**TRINITY COUNTY PLANNING COMMISSION
STAFF REPORT**

PROJECT NAME: Lance Gulch Road/State Route 299 Intersection Control Project

PROJECT NUMBER: PW-16-06

**RESPONSE TO COMMENTS FROM SCOTT WHITE
LETTER DATED NOVEMBER 2, 2016**

Mountable Splitter Island for local Fire Dept.

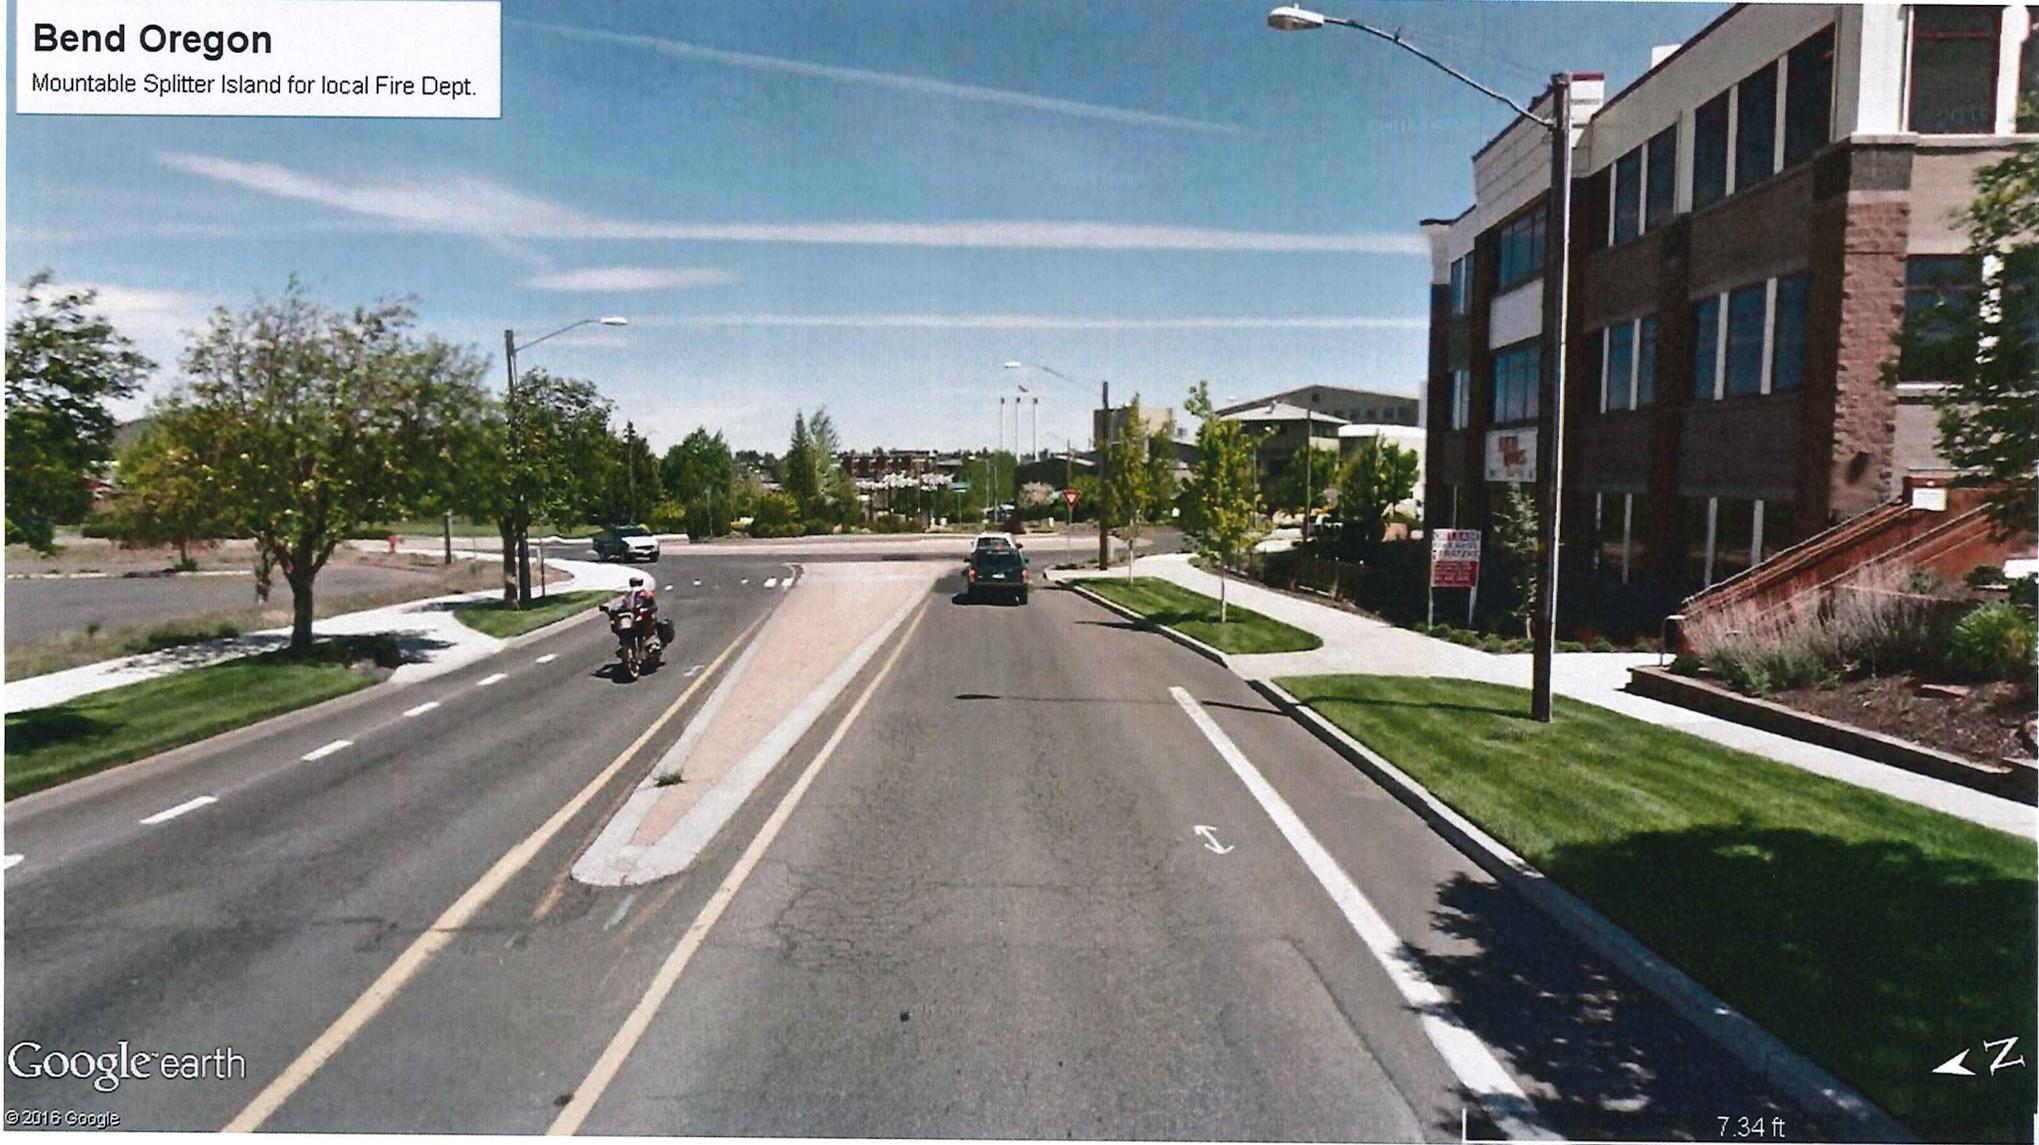
COMMENT #2: Mitigation Measure 14.2 also proposes a mountable splitter island on the Lance Gulch Road approach to allow CHP and other emergency vehicles to pass other vehicles and enter the roundabout without waiting. The comment states that this "painted" center island will make it easier for a driver approaching SR 299 on Lance Gulch Road to turn left into the roundabout and travel directly into the path of westbound vehicles on SR 299. Also, without a raised splitter island, there will be no refuge for pedestrians crossing Lance Gulch, particularly from vehicles using the free right turn lane from westbound SR 299 to Lance Gulch Road, or from emergency vehicles using the mountable splitter island to pass vehicles and enter the roundabout, as the mitigation measure intends.

RESPONSE #2: The comment refers to a painted splitter island rather than a solid splitter island. The proposed mountable splitter island would be a raised center island with rounded, mountable curbs. Exhibit B shows a similar mountable center island at a roundabout near a fire station in Bend, Oregon. The splitter island will not just be painted, it will be raised and made of a different material (concrete and/or brick), to make it clear that it is not to be driven on. The maneuver of making an errant left turn

EXHIBIT F
ROUNDAABOUT DESIGN SUGGESTION
FROM JOHN HAMILTON

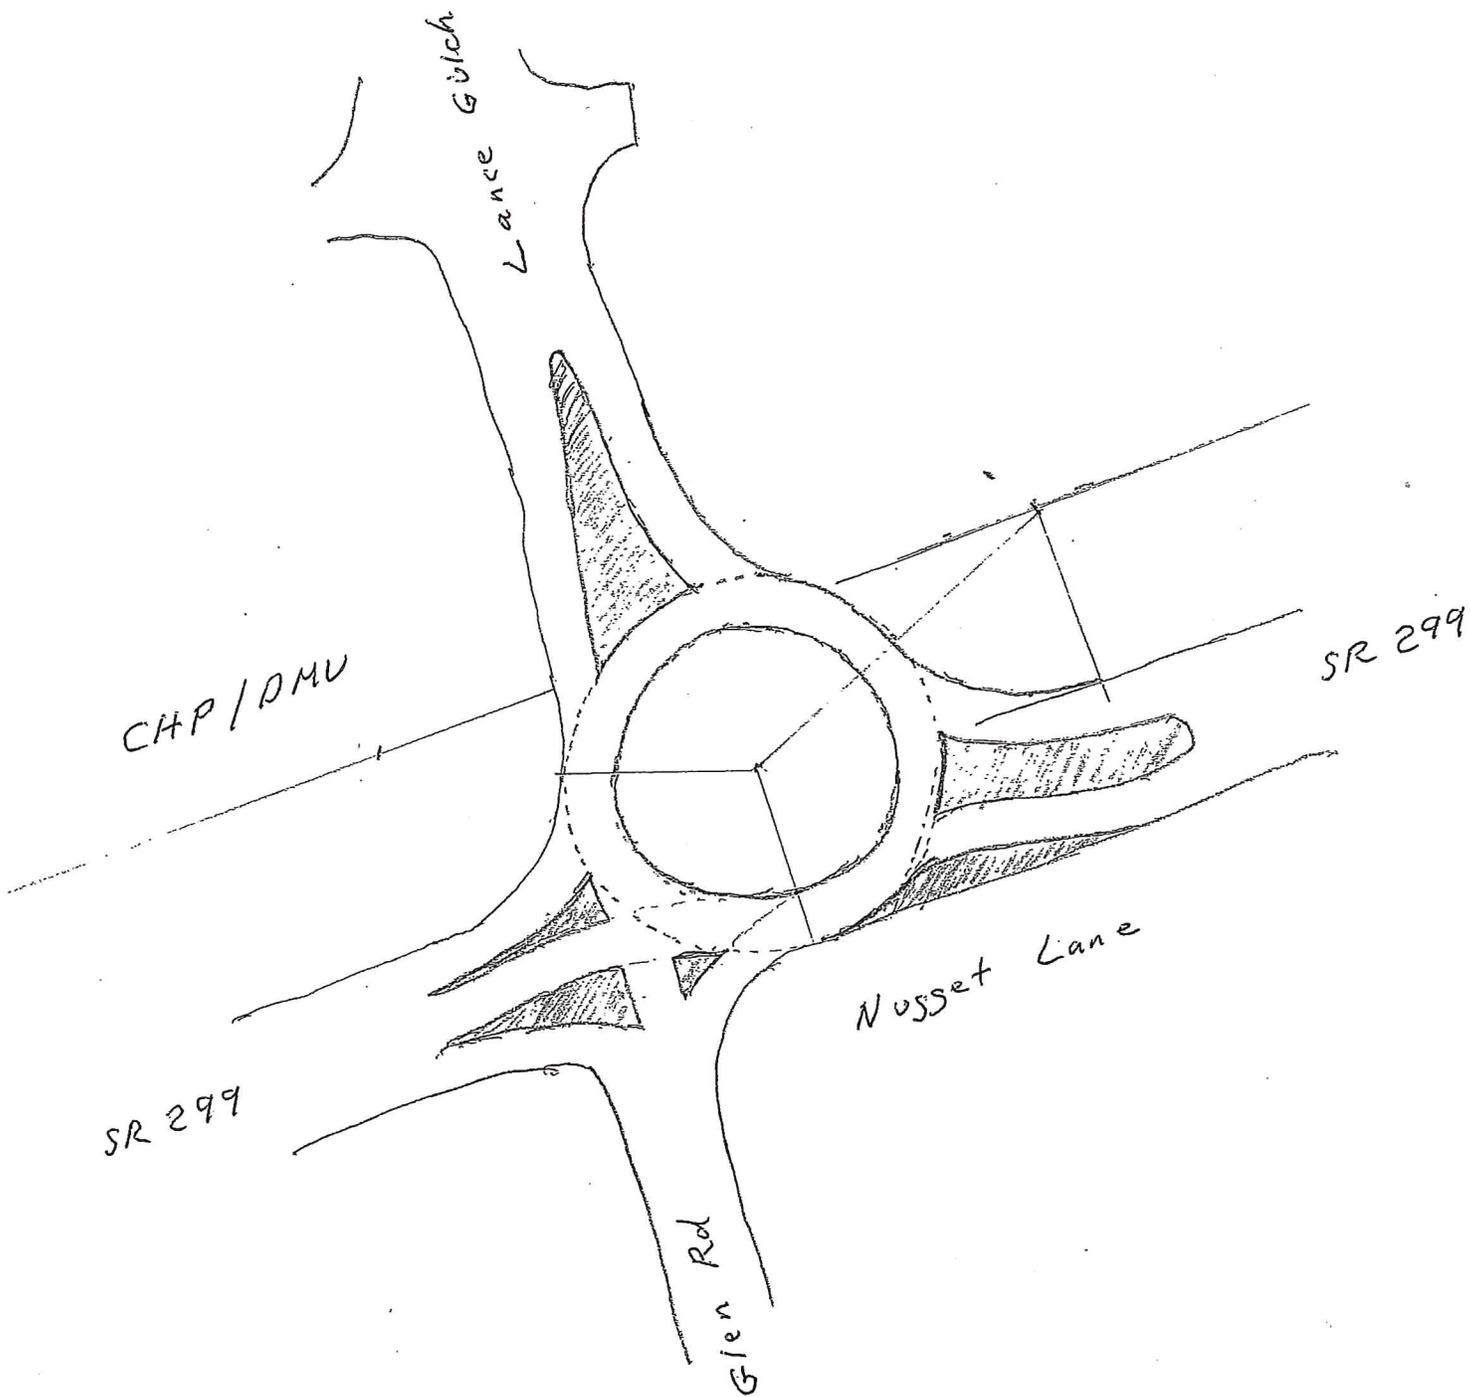
JOHN HAMILTON: Mr. Hamilton provided a drawing of a roundabout that could be constructed closer to the vacant lot adjacent to CVS, without impacting Nugget Lance. He stated that he used to work for a traffic engineer, and that he had presented this concept before but got no response.

RESPONSE: The drawing is attached as Exhibit F. Kittelson & Associates, the design consultant for the proposed roundabout, as well as County Engineers and roadway design consultants from Quincy Engineering, consultants for the Lance Gulch Road project all reviewed and commented on the drawing. They found it similar to a drawing that Rob Stinger, Chief of Traffic Engineering & Operations for Caltrans District 2, had provided a couple of years ago, but that was rejected mainly because it eliminated the left turn from westbound SR 299 onto Glen Road, and because it would require realignment and reconstruction of long sections of Lance Gulch Road and SR 299. The roundabout provided by Mr. Hamilton would probably also require realignment of Lance Gulch Road and SR 299, but the drawing has no background or scale so it is difficult to see how much.
